PLANNING REPORT

PLANNING AND ZONING COMMISSION

**4. Perimeter Center, Subarea J – MAG – Porsche 6325 Perimeter Loop
08-073AFDP Amended Final Development Plan**

Proposal: External building modifications, and a wall sign for a portion of an existing automobile sales and service establishment located within Subarea J of the Perimeter Center Planned Commerce District, located on the east side of Perimeter Loop Road, at the intersection with Mercedes Drive

PROPOSED ELEVATIONS

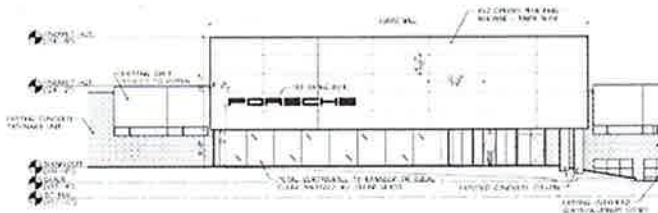
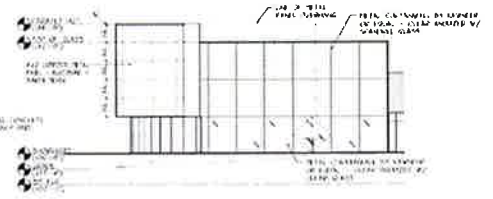
The Perimeter Center Planned Commerce District development text requires “striking, noteworthy and innovative architecture” and states that “a dealership with box-like buildings will not be considered a use of right.” The MAG building was designed with a cohesive theme of prominent, angled showrooms constructed of glass. Even with a slight curve in the proposed design, the Porsche building resembles a “box-like” feature. Additionally, the building materials change to metal panels for a majority of the curved wall and only the lower portion incorporates glass.

Criteria not met: The proposal does not conform to the preliminary development plan or development text for the area in regards to offering “striking, noteworthy and innovative architecture” or that “a dealership with box-like buildings will not be considered a use of right.” This modification interrupts the cohesive architectural style that has been created on the site by significantly altering the very form that makes the design innovative, and “non-box” like.

PROPOSED SIGN

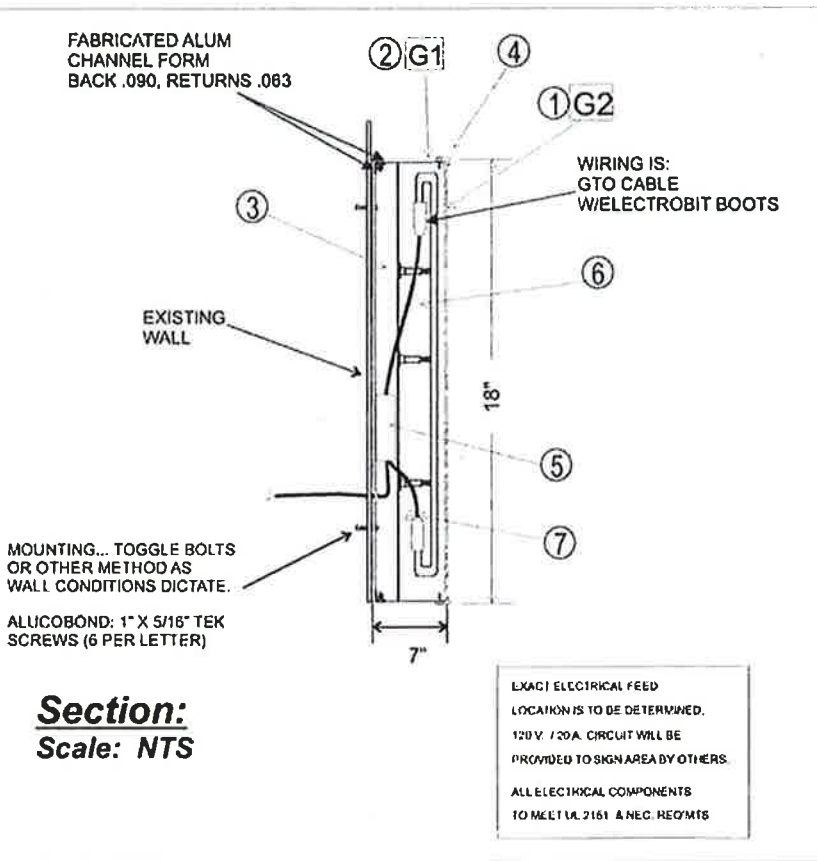
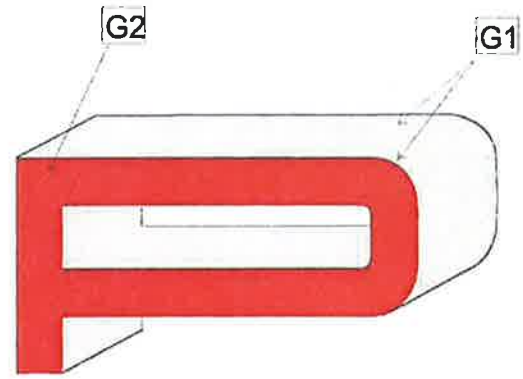
Proposed Sign. The applicant is proposing a new 33 square foot sign on the north side of the eastern elevation at the maximum permitted height of fifteen feet. The sign will be constructed using aluminum channel letters with red vinyl text reading “Porsche.” Each letter would be internally illuminated using standard neon tubing.

Criteria not met: The proposal conforms to the preliminary development plan requirement for appropriate landscaping details, and provides adequate stormwater management. However, the use of wall signs was prohibited in the development text. A wall sign in this portion of the site would not be in character with the rest of the building.
